Addendum # 1

Bid Opportunity: 25-7706-RFT - Glenview Park Secondary School Elevator and Science Laboratory Renovation

RE: Glenview Park Secondary School
Elevator & Science Laboratory Renovation
Cambridge, ON

ADDENDUM 01

Further Electrical Clarification:

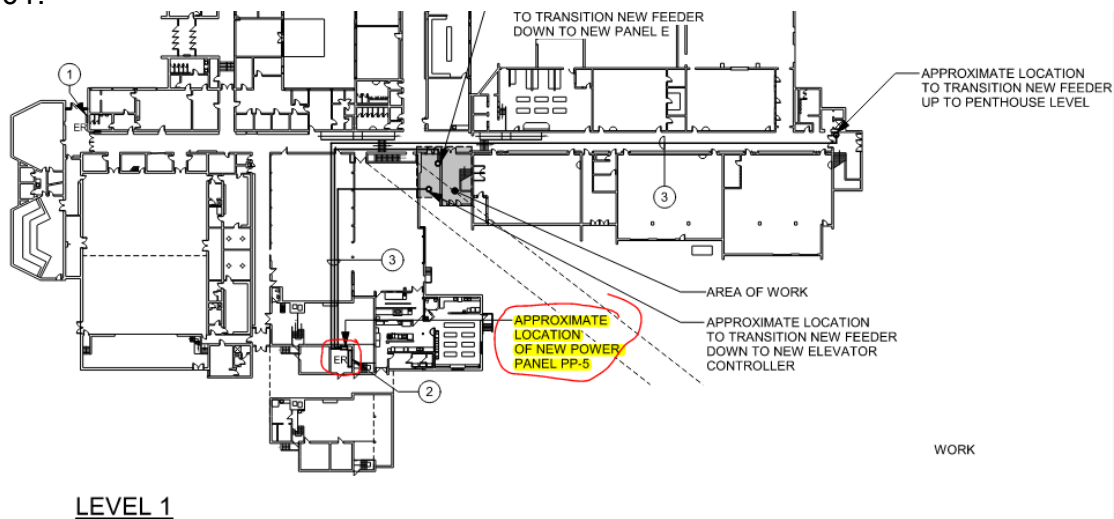
Location of new Panel PP-5 as noted on the overall plan level 1 on drawing E101.

The new distribution panel PP-5 is planned to be added in the Main Electrical Rm where the Main Switchboard is located.

From this panel, we will have a new breaker to feed the elevator, new sub panel, and new distribution panel PP-MP up in the penthouse for all the Mechanical Equipment. This is noted on drawing E401.

HVAC-5 UNIT DETAIL
SCALE: N.T.S.

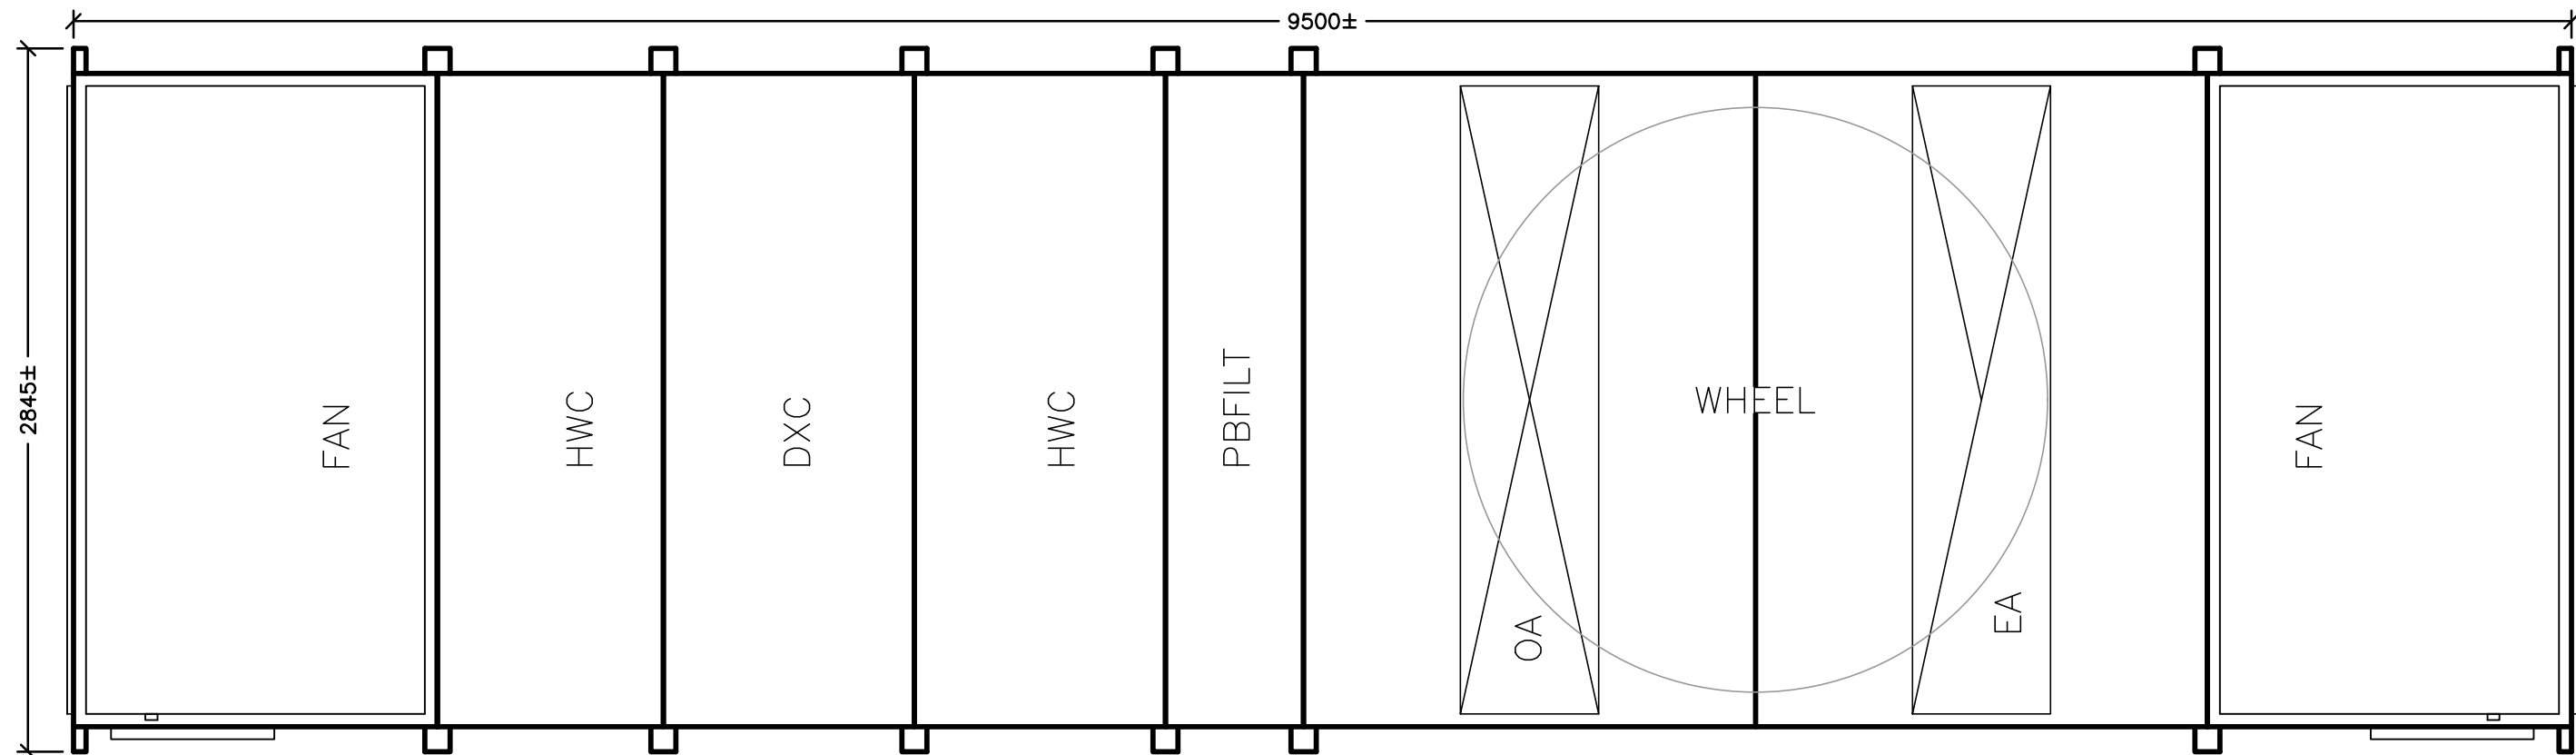
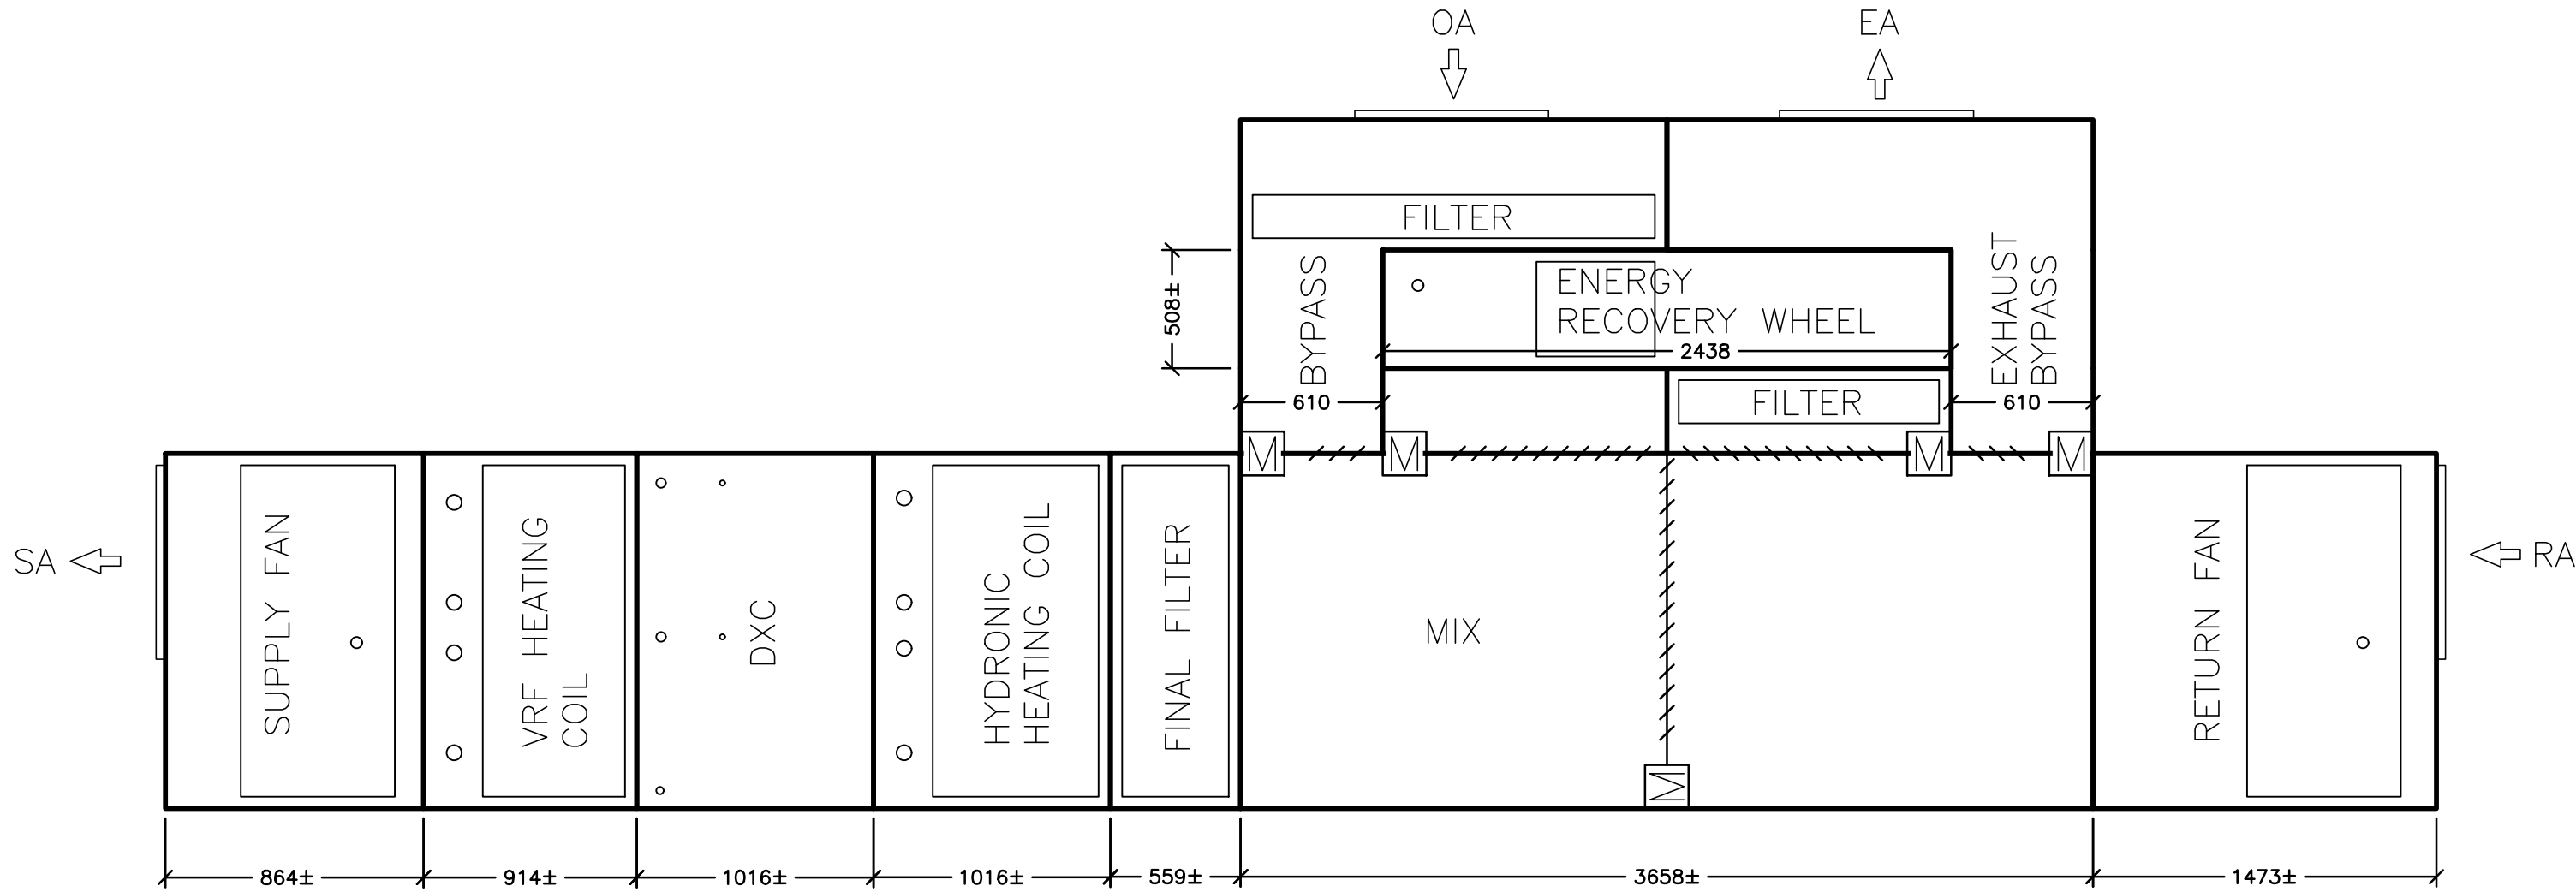
- 1.0 Reference Attached Reissued Drawings M1.1 and M1.2
- .1 Rename/revise 'Contractor Staging & Access to Site (Phase 1)' detail as per attached reissued drawing M1.1.
 - .2 In 'Fan Schedule (Phase 1)', revise EF-5 and EF-6 as follows:
 - .1 Capacity (cfm): 1200
 - .2 ESP (in wc): 0.375
 - .3 Accept. Manuf: Penn Barry FX12BH
 - .3 In 'Fan Schedule', remove general fan notes mentioning "ceiling fans".
 - .4 Add 'Pump Schedule' as per reissued drawing M1.1.
 - .5 Revise 'Unit Detail' as per attached reissued drawing M1.2.

HVAC UNIT SHALL BE DELIVERED IN SECTIONS AND ASSEMBLED ON SITE IN PLACE. IT IS THE RESPONSIBILITY OF THIS CONTRACTOR TO INSTALL THE UNIT IN PLACE TO THE STANDARDS OF THE MANUFACTURER

MECHANICAL ROOM C200 PART PLAN BAS (PHASE 1)
SCALE: 1:50

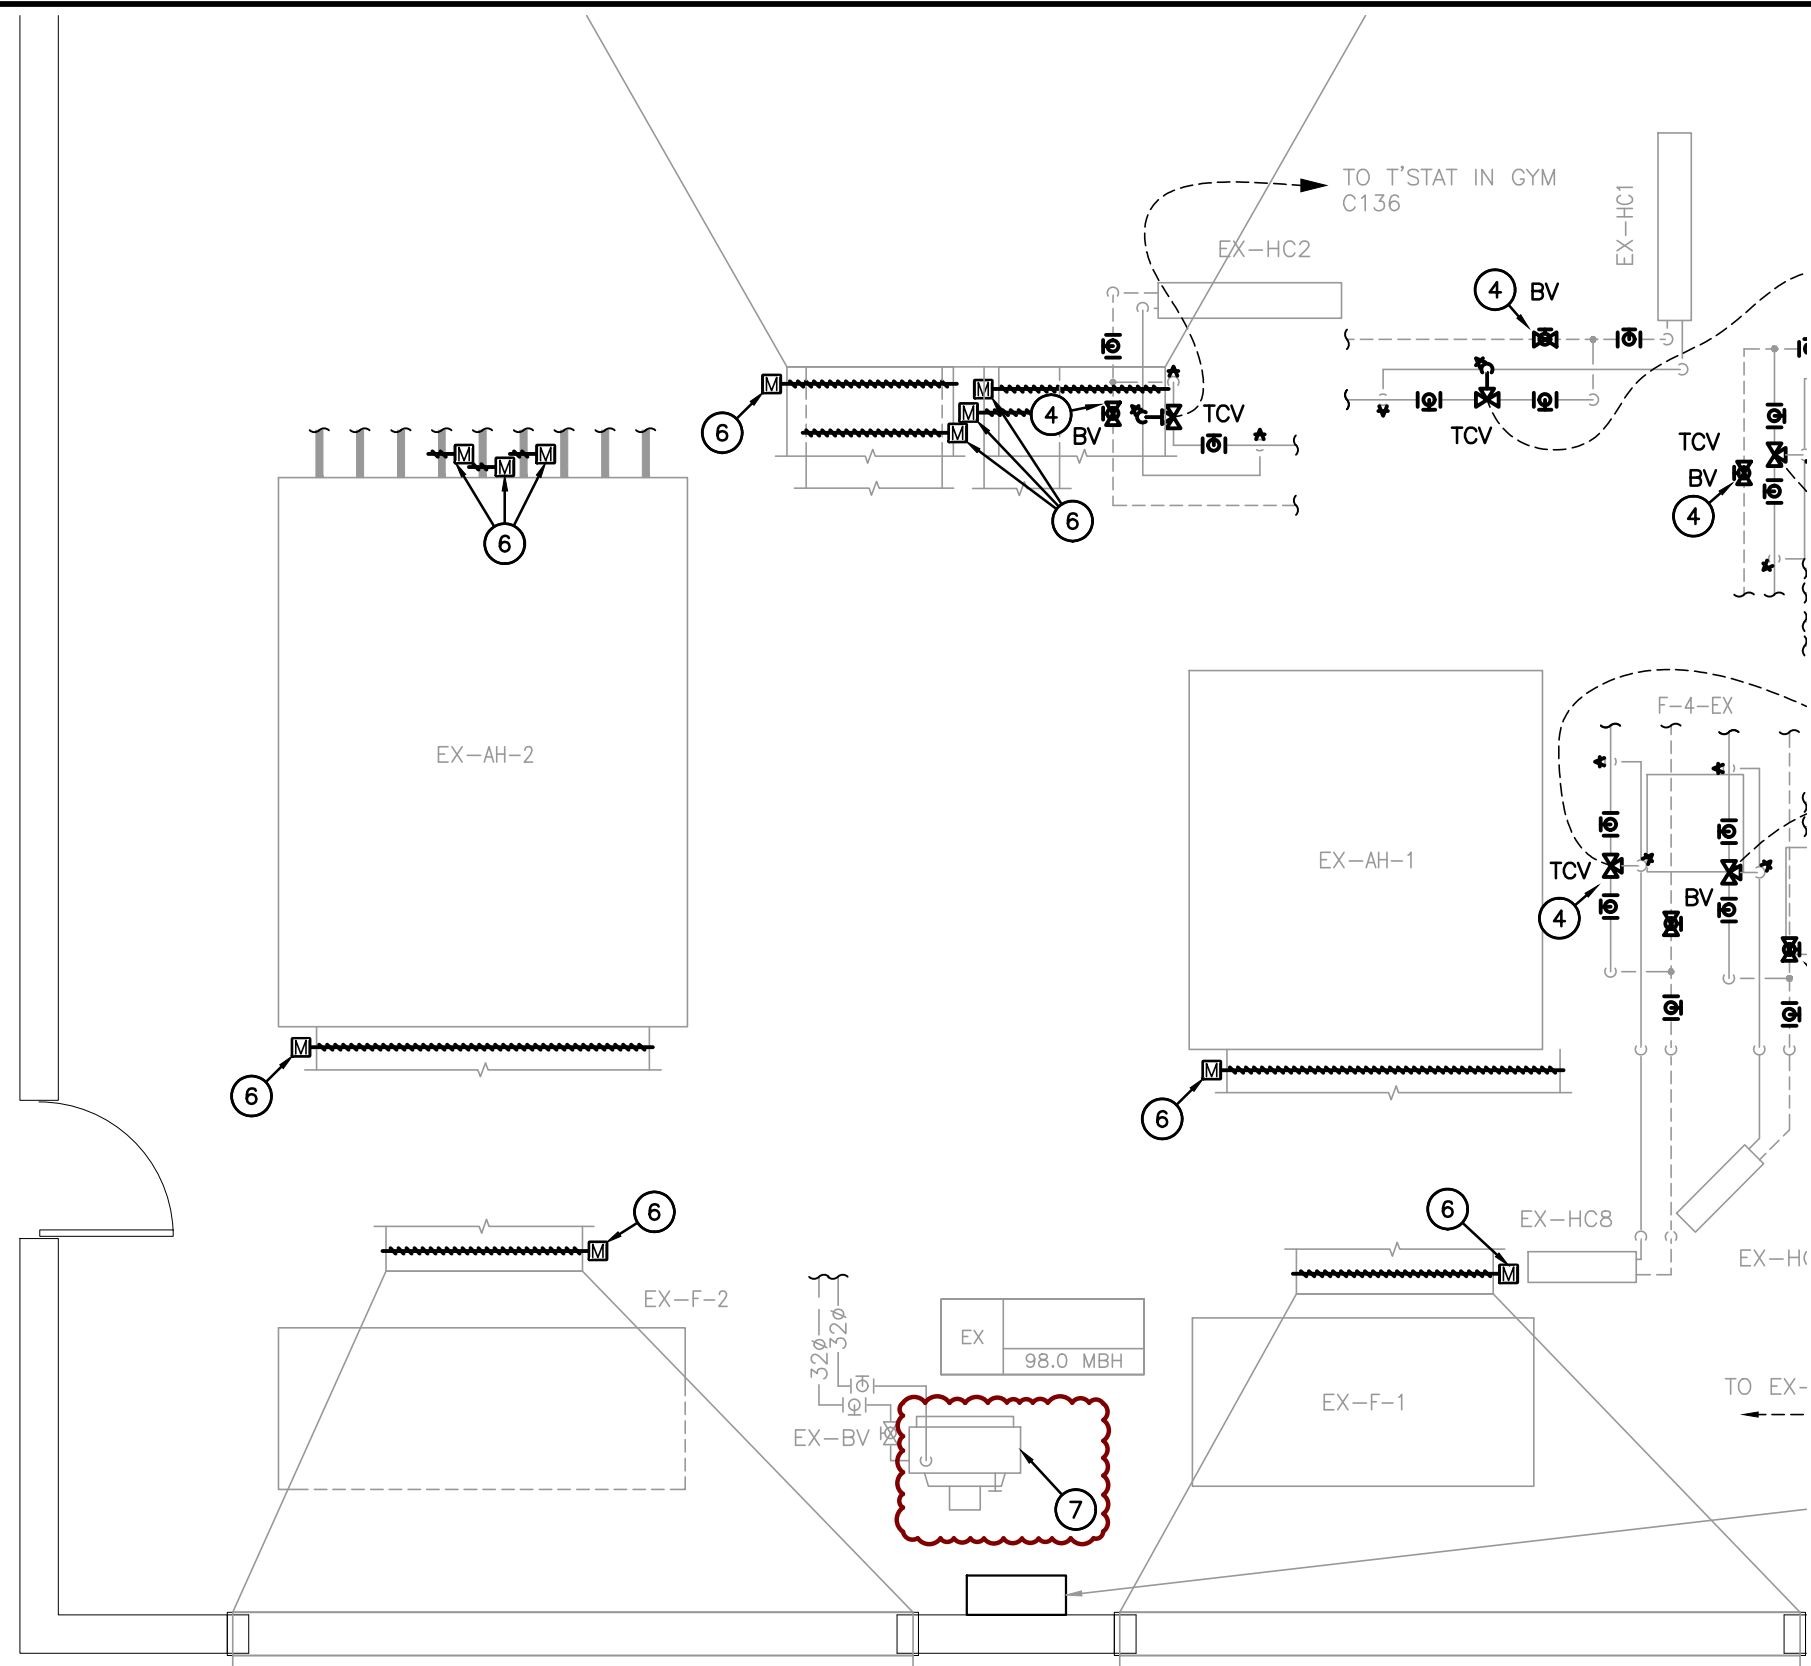
- 4.0 Reference Drawing M2.4 and Attached Sketch ADD01-M03
- .1 In 'Mechanical Room C200 Part Plan BAS (Phase 1)', add the following note to the existing unit heat adjacent to EX-F-1:
"Existing unit heater to be integrated to BAS. All existing controls, actuators, and sensors to be replaced completely."

7. EXISTING UNIT HEATER TO BE INTEGRATED TO BAS. ALL EXISTING CONTROLS, ACTUATORS, AND SENSORS TO BE REPLACED COMPLETE.
